THE CONTROL OF HEAVY LOADS AT
NINE MILE POINT UNIT 2

DOCKET NO. 50-410

Nine Mile Point Unit 2

4

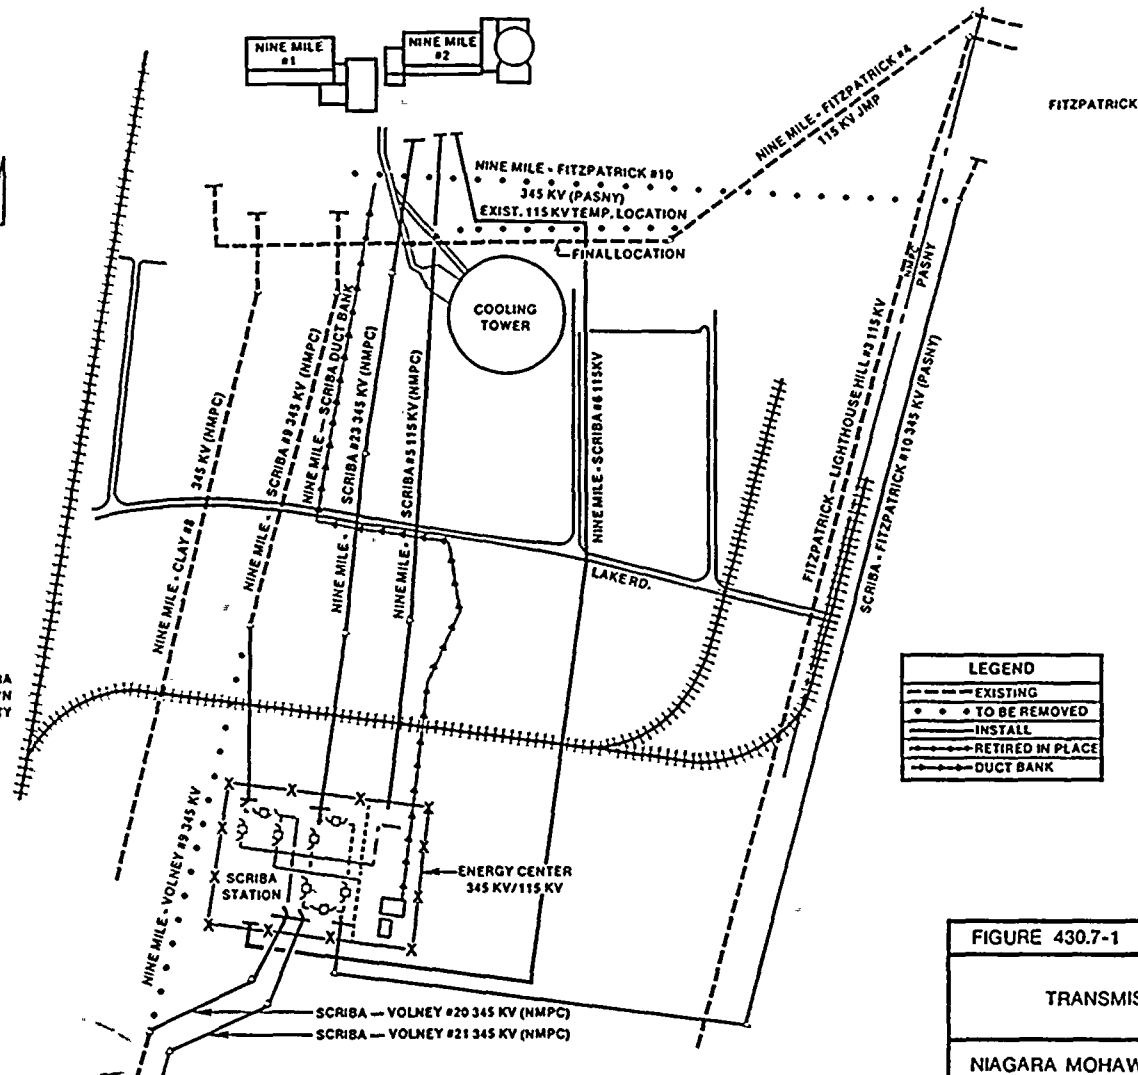
- a. A revised Figure 8.2-1 and narrative description of the new offsite power circuit configuration.
- b. Drawings of the physical orientation of the offsite circuits around the Nine Mile Point and Fitzpatrick Power Stations. Suggest using Figures similar to 2.1-2 and 2.1-3.
- c. Drawings which show tower spacing for lines which share a common right of way.
- d. Steady state and transient stability analyses results for the new offsite configuration including the loss of the largest capacity to the grid or removal of the largest load from the grid.

See revised Sections 8.1 and 8.2. A tower spacing drawing is not provided since the 115 kV is not on a common right-of-way. See Figure 430.7-1.

FIGURE 9.5-41 a

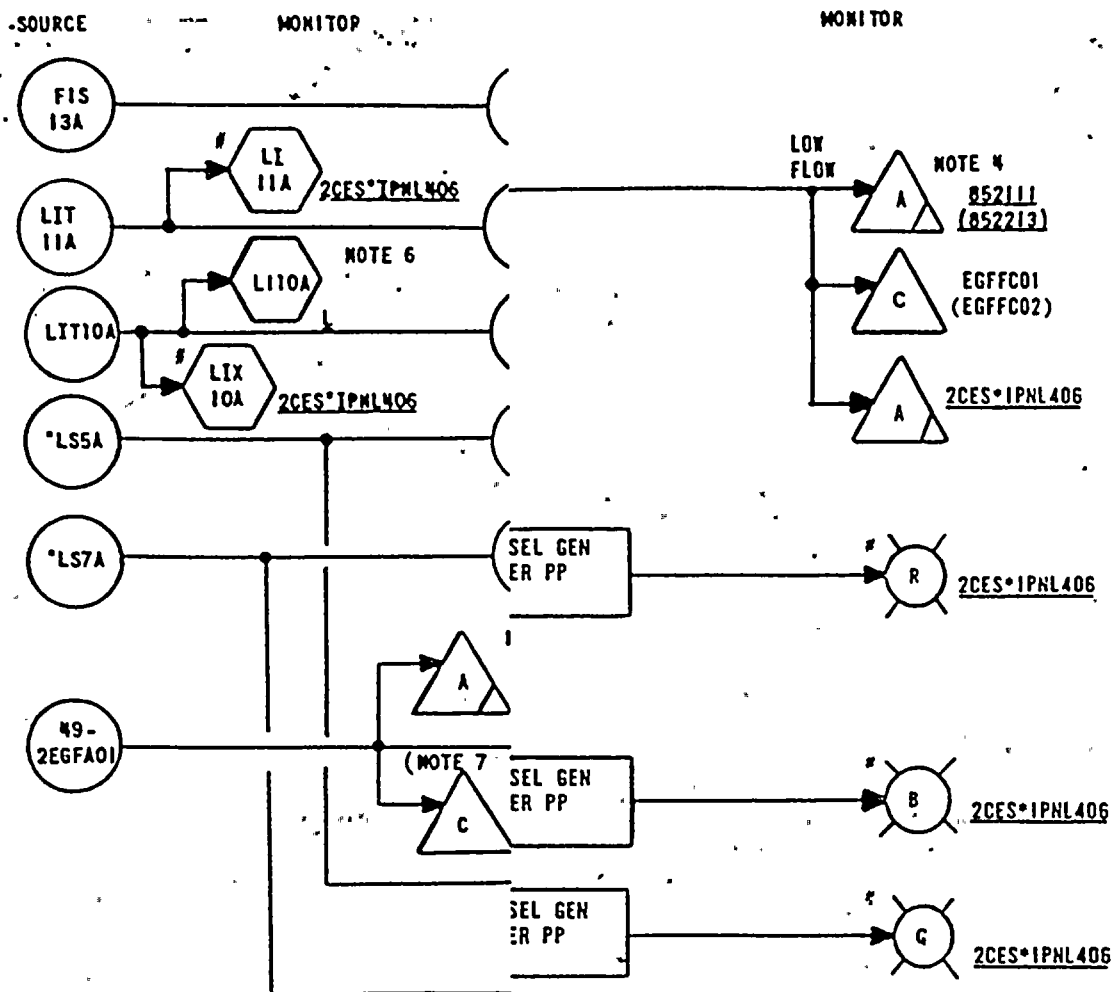
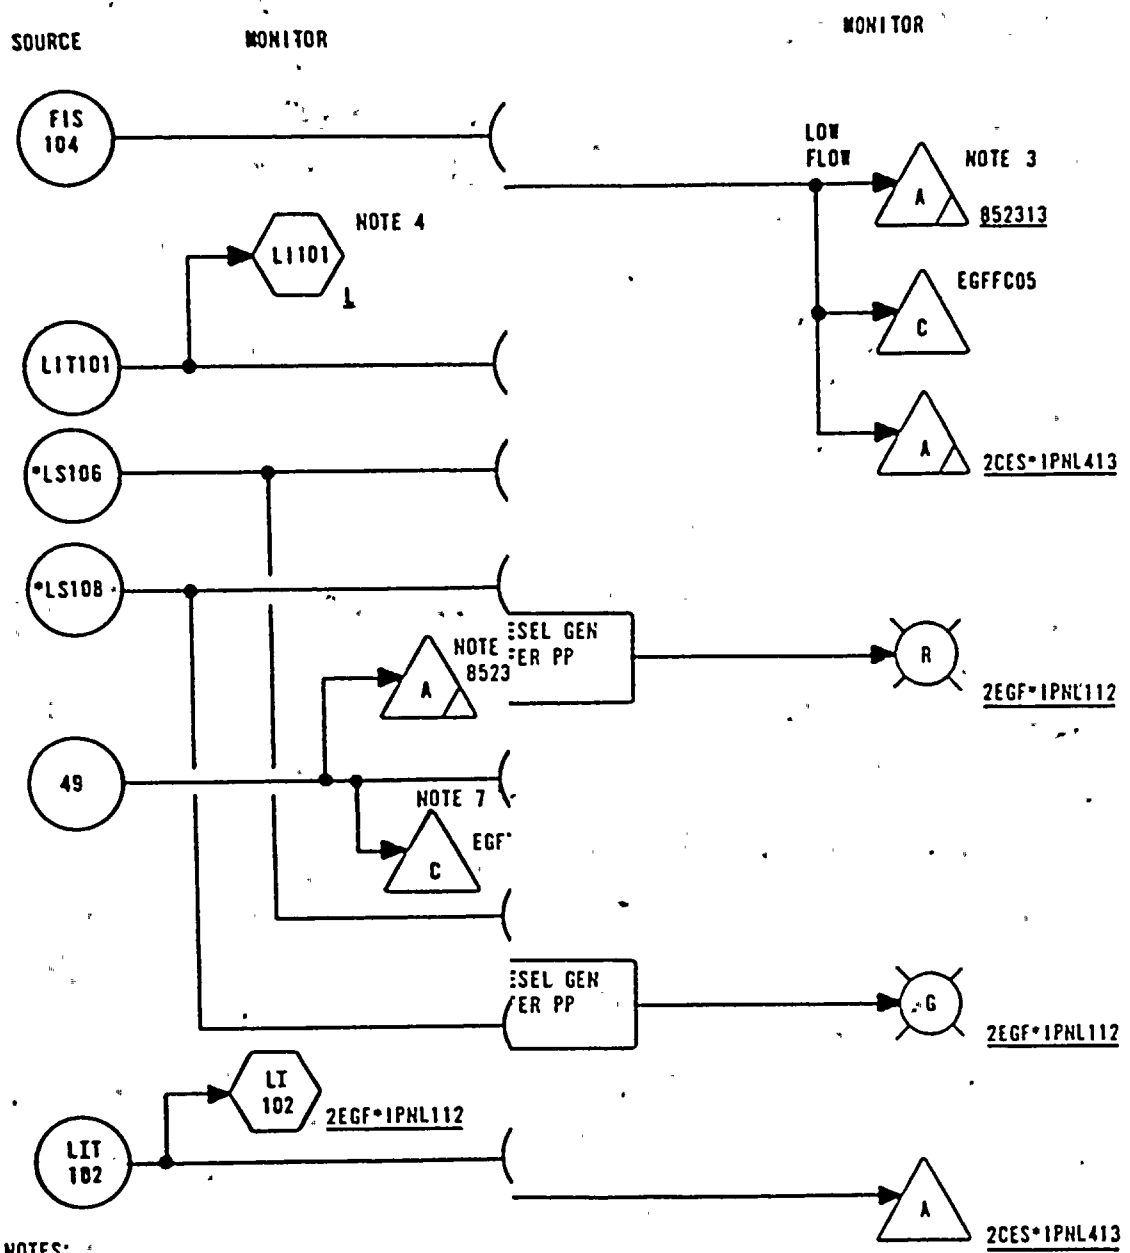
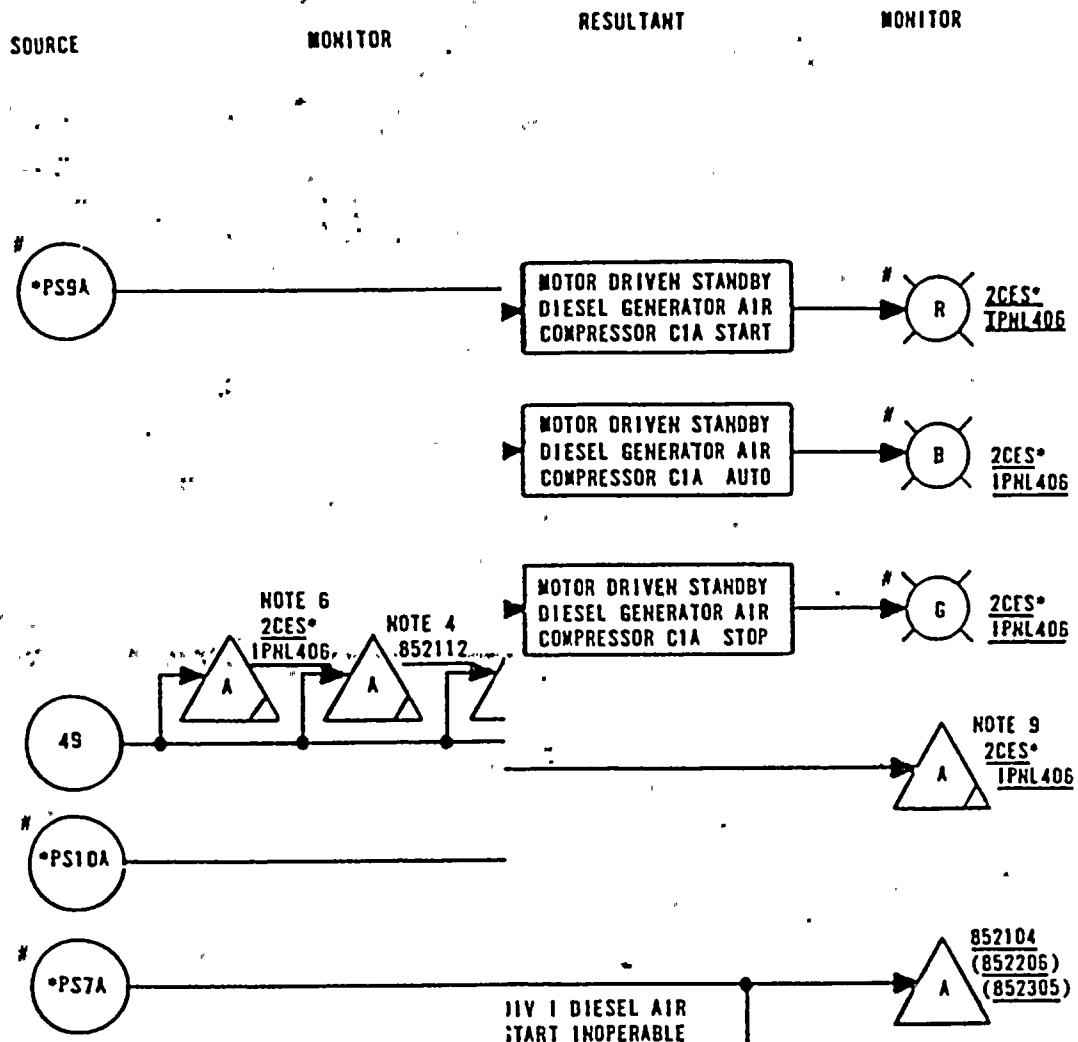
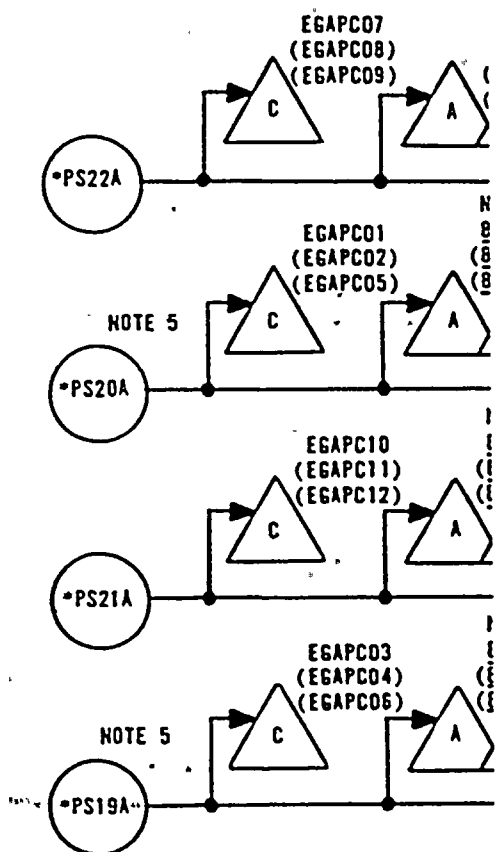
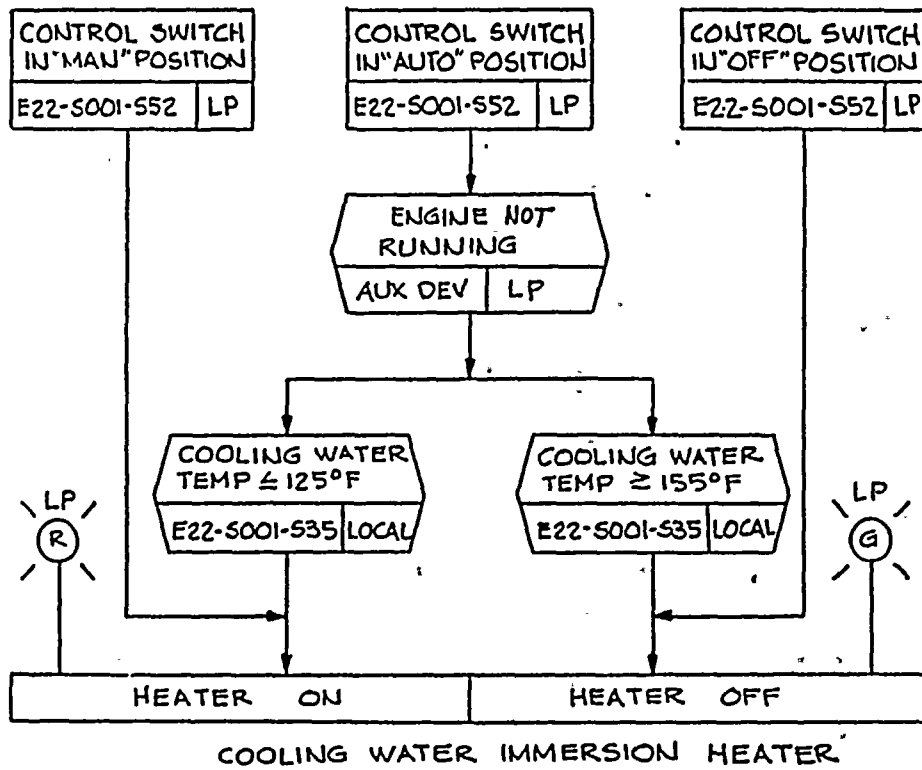
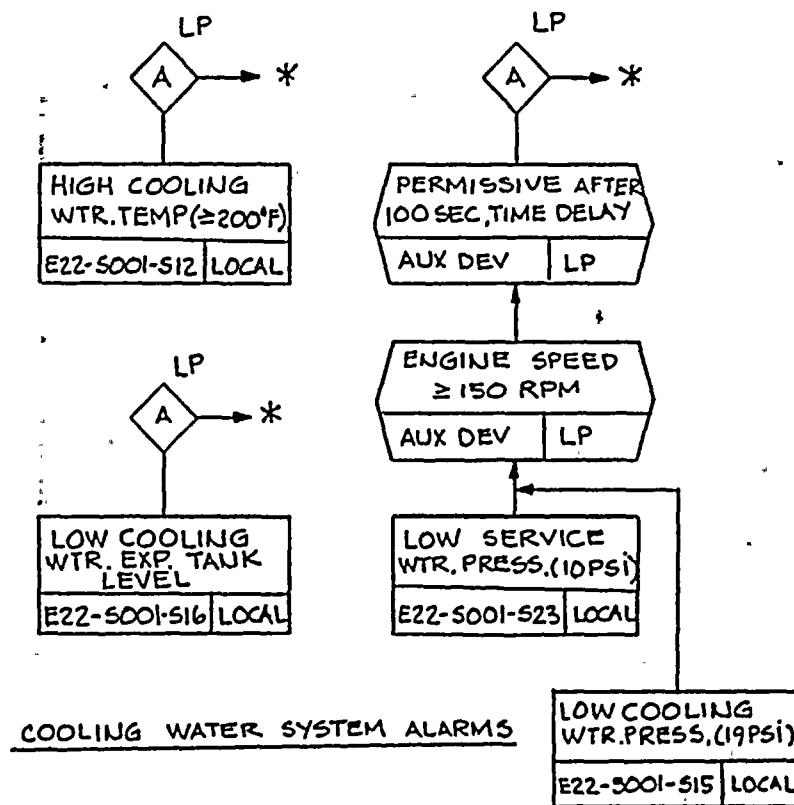
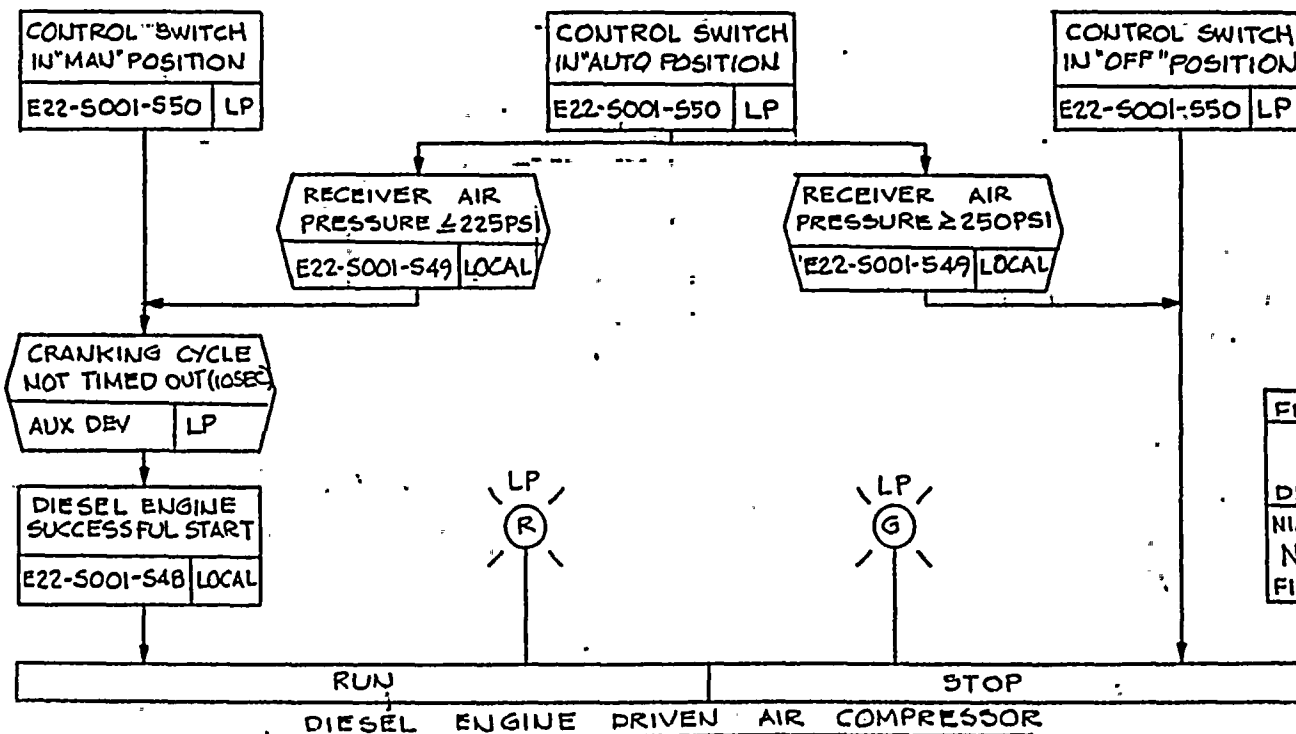
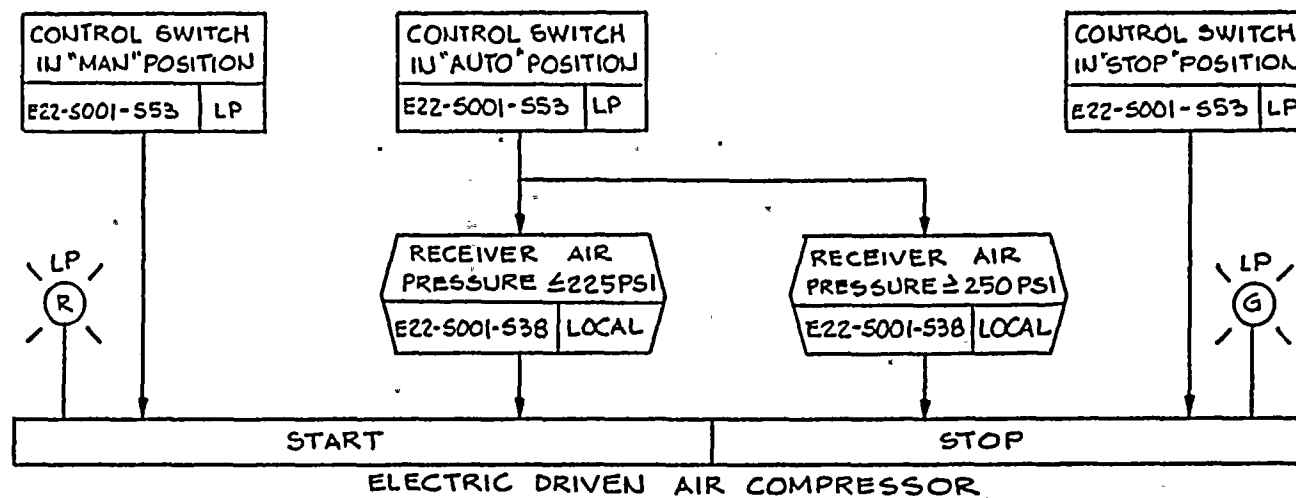
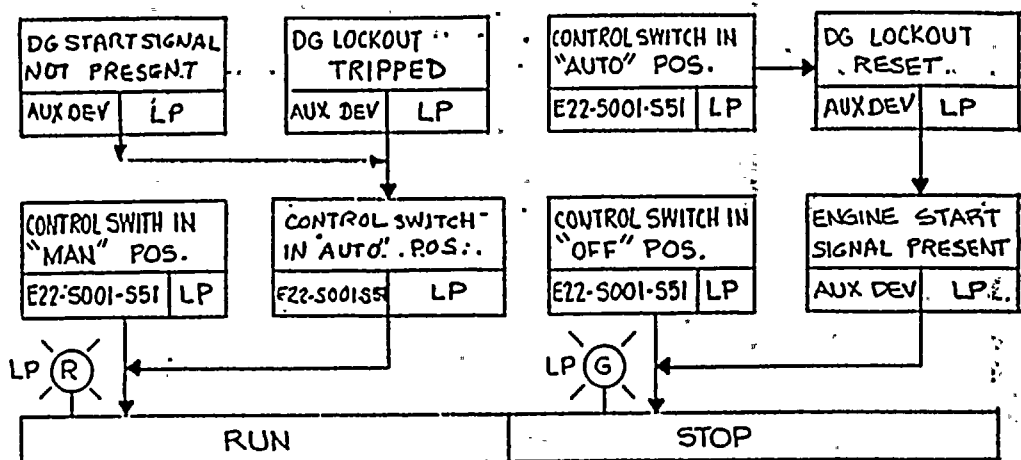
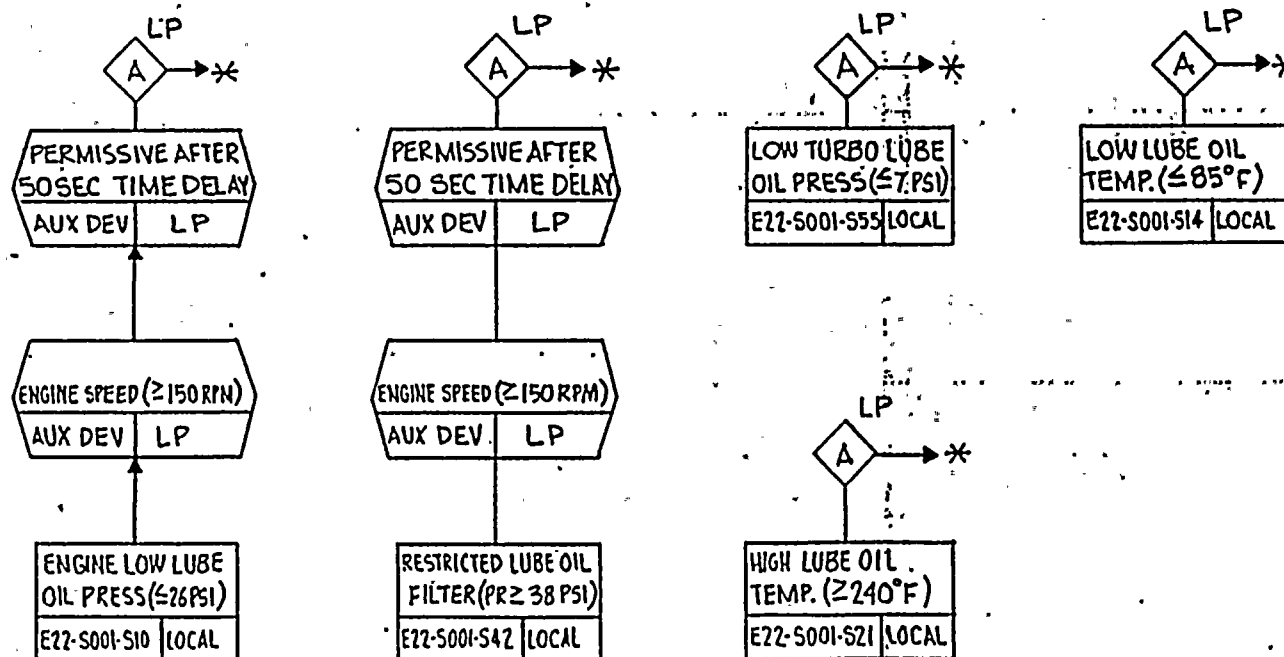
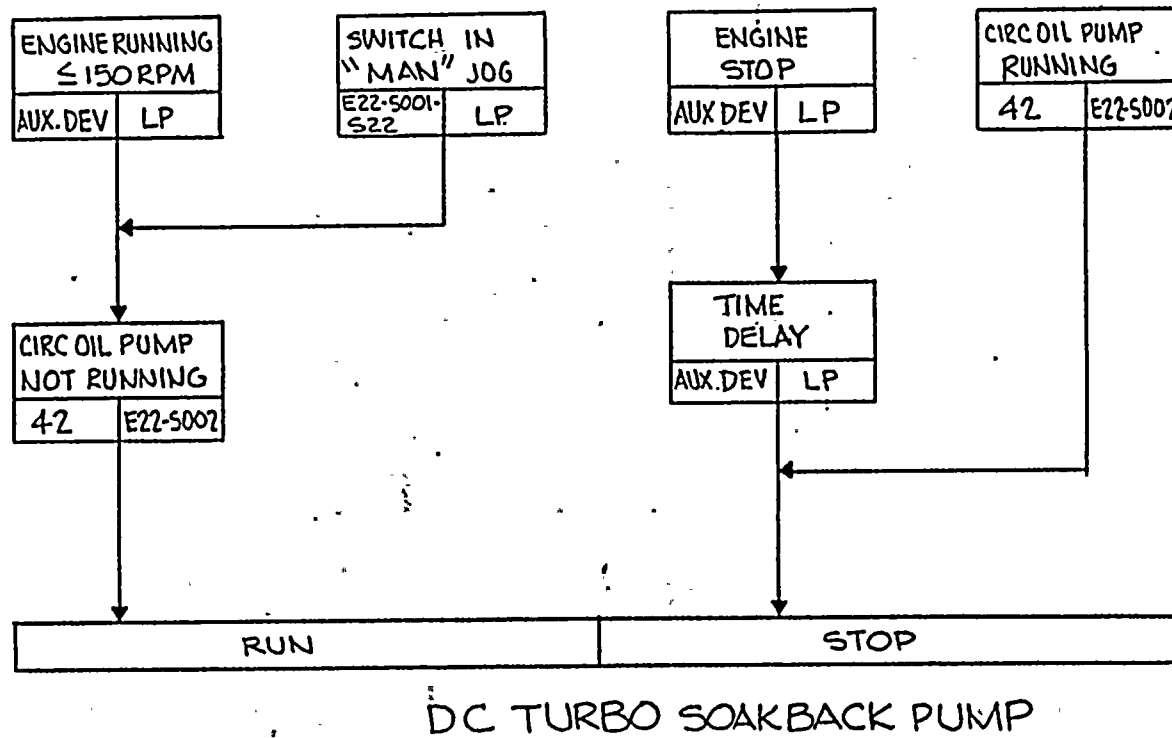
Not acceptable. See comments for Q 430.53

175

- (h) See the newly added Figure 9.5-41c.
- (i) See the newly added Figure 9.5-41b for cooling water system logic diagram. Item 16 is shown on Figure 9.5-43.
- (j) See the newly added Figure 9.5-41d for the lubrication system logic diagram.
